Wichita-Sedgwick County Metropolitan Area Planning Department

Re: **BZA2025-00088:** Administrative Adjustment in the City to permit an accessory structure (carport) in front of the principal structure on property zoned SF-5 Single-Family Residential District, located two blocks south of East Pawnee Avenue and one-block east of South Washington Avenue (1102 E. Marion St.).

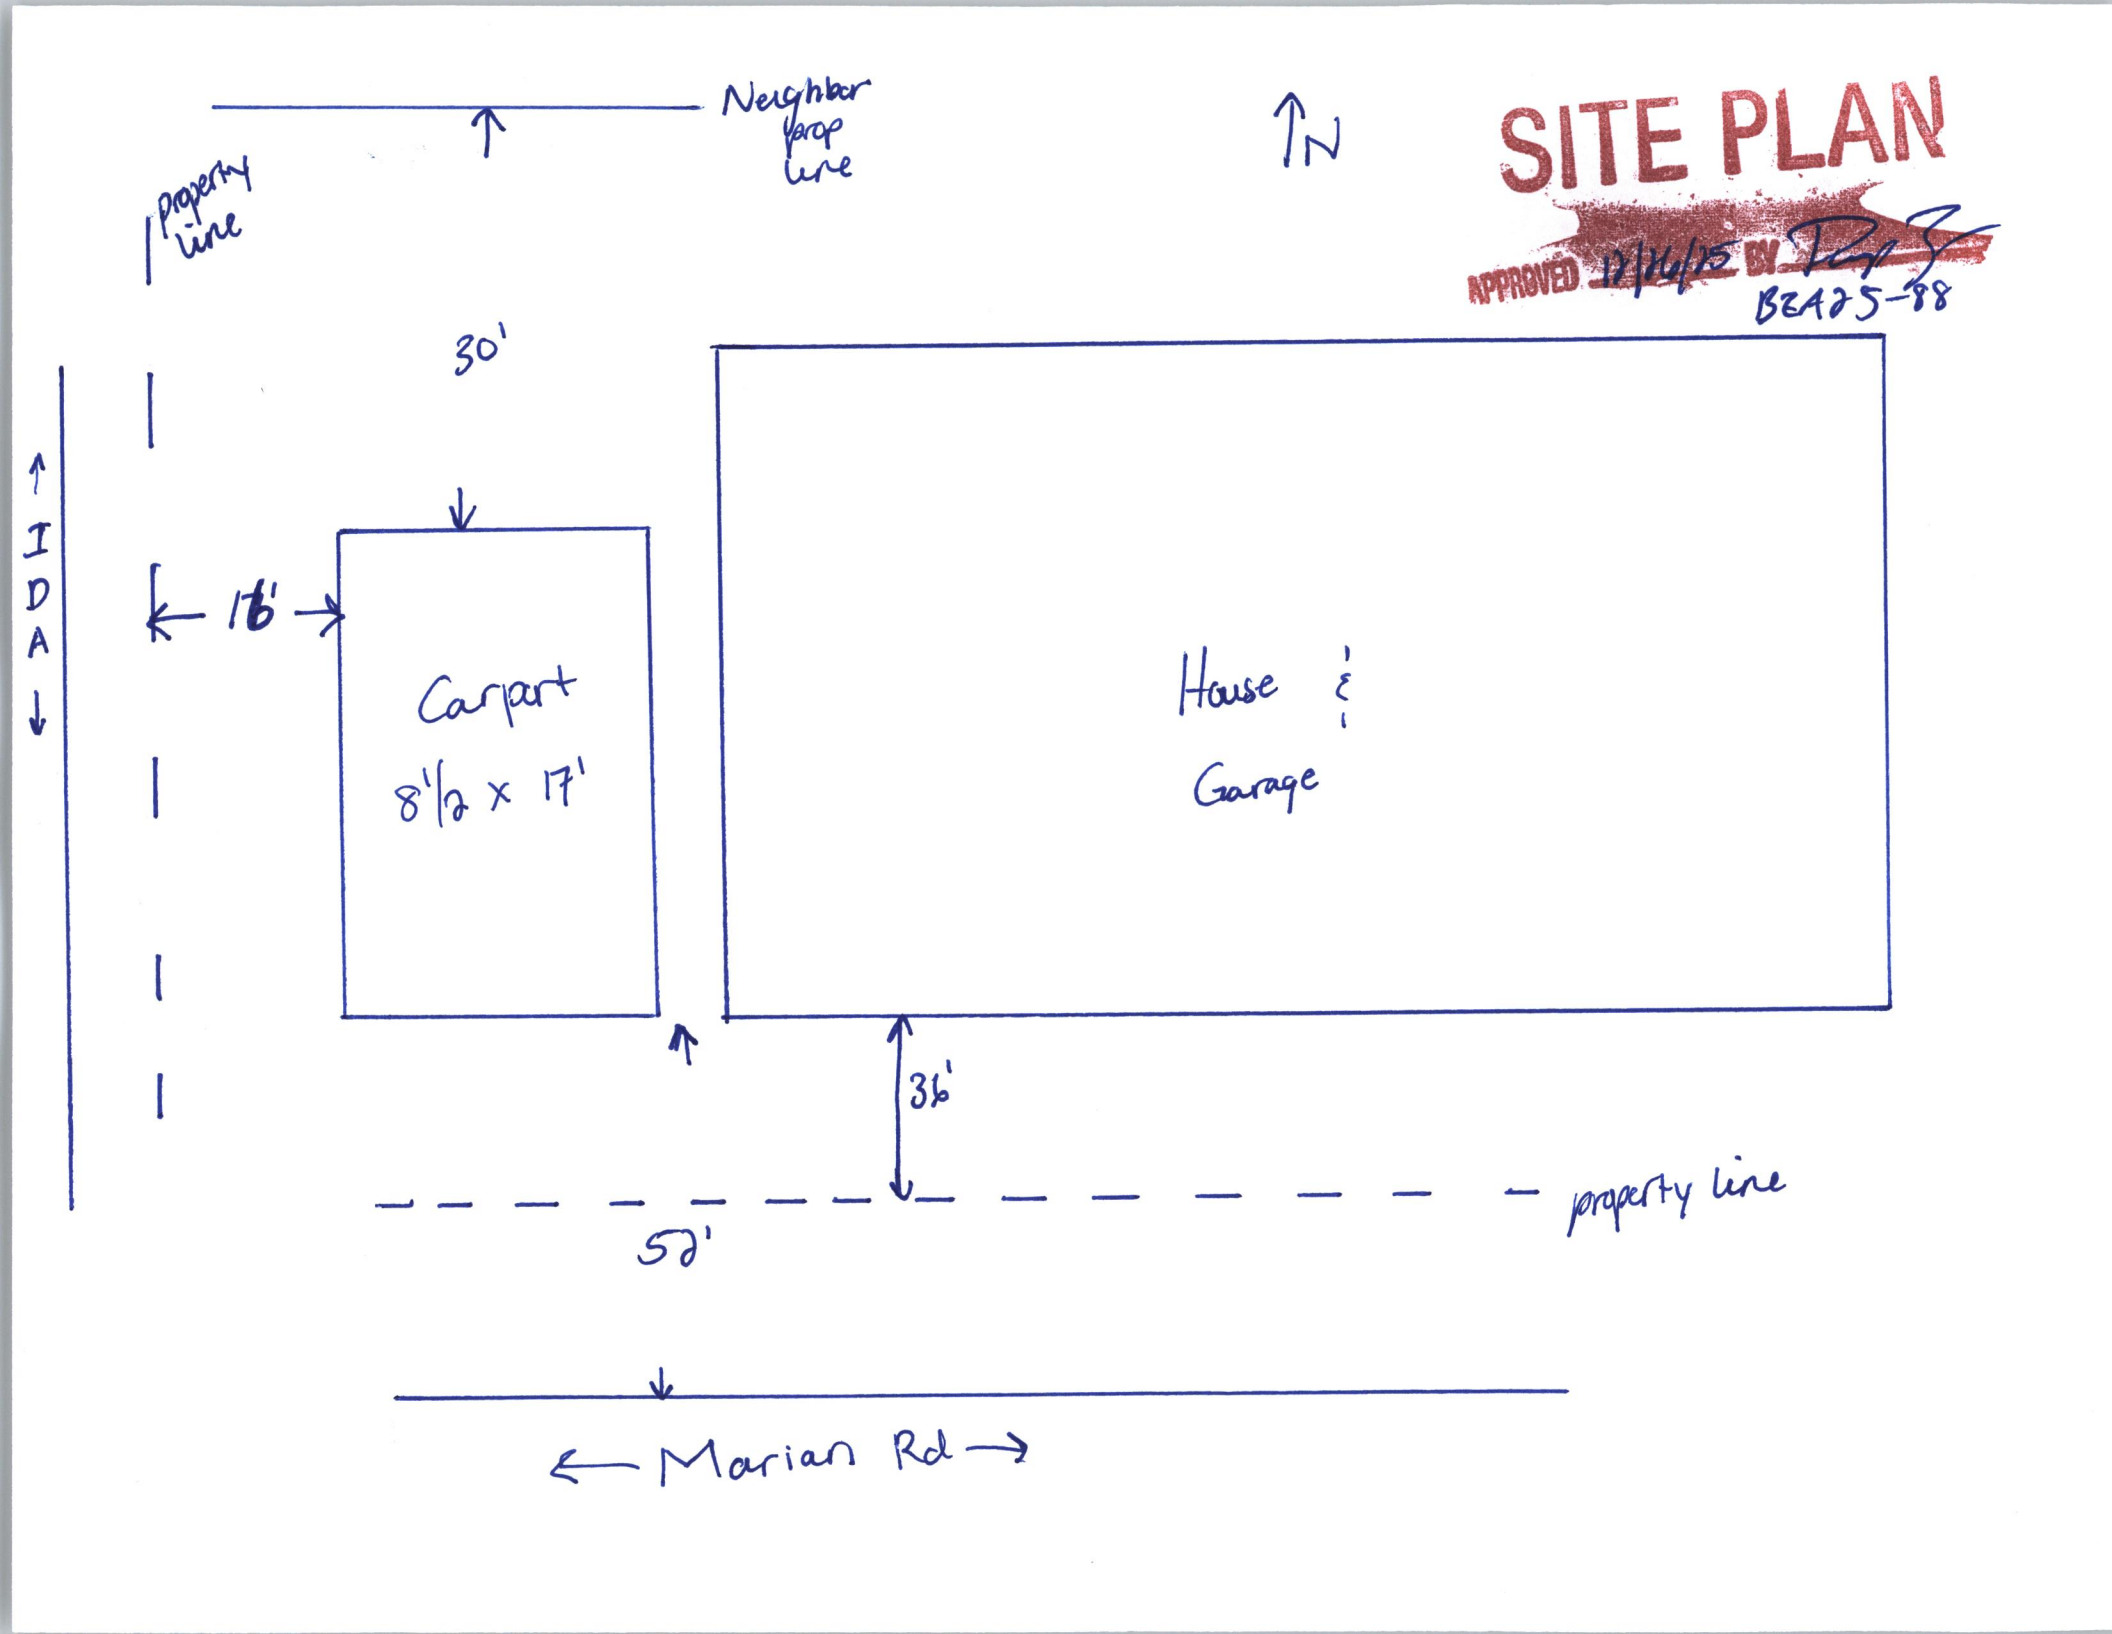
We have reviewed your request for a Zoning Adjustment to permit an accessory structure (carport) in front of the principal structure on 0.303 acres. Though the dwelling on the subject site is oriented toward East Marion Avenue, South Ida Avenue is considered the "front" of the lot because it is the narrowest lot dimension along a street. There are no platted setbacks on the subject lot. The proposed carport would encroach into the 25-foot west, front zoning setback by 6 feet. The site plan indicates there would be at least 16 feet between the carport and the front property line and 36 feet from the south, street side setback.

1) Impact on safety and convenience of vehicular and pedestrian circulation: Public vehicular and pedestrian circulation will not be affected, and the structure will not interfere with traffic circulation patterns because the proposed carport is approximately 19 feet from the front property line along South Ida Avenue to the west and 36 feet from the south property line, along East Marion Street.

Our signatures below indicate that a Zoning Adjustment to permit an accessory structure to be placed in front of the principal structure on less than five acres of land for the aforementioned property is hereby GRANTED, subject to the following conditions:

1) The permitting of an accessory structure in front of the principal structure shall apply only to the proposed carport illustrated on the approved site plan. All other structures or additions on the subject property shall conform to the development standards of the Unified Zoning Code unless a separate Zoning Adjustment or Variance is granted.
